I object to the WestConnex M4-M5 Link proposals as contained in the EIS application # SSI 7485, for the reasons set out below.

Application Number: SSI 7485

Application Name: WestConnex M4-M5 Link

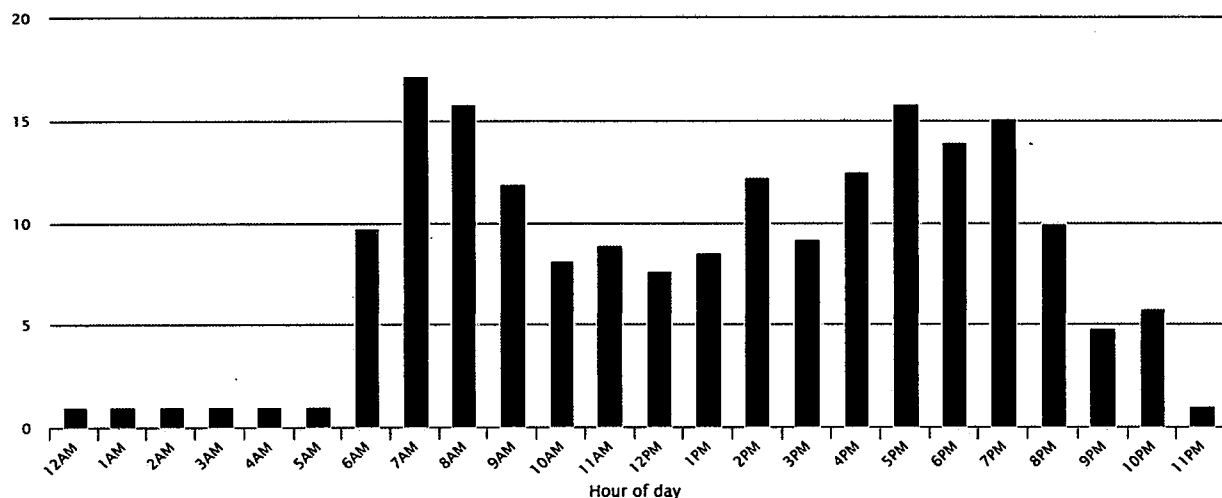
- I object to the EIS because the proponent has failed to take account of the cumulative impact of its proposed Darley Road, Leichhardt civil and tunnel site operations and the aircraft noise which the residents near the site already endure.

The attached extract from Webtrak shows that Darley Road, Leichhardt and adjacent streets are directly under the flight path.

Airservices Australia reports that in April to June 2017 the number of average daily noise events over 70 dBA. In Leichhardt this is an average of 16- 17 per hour over the peak morning period and 16 per hour in the early evening peak period.
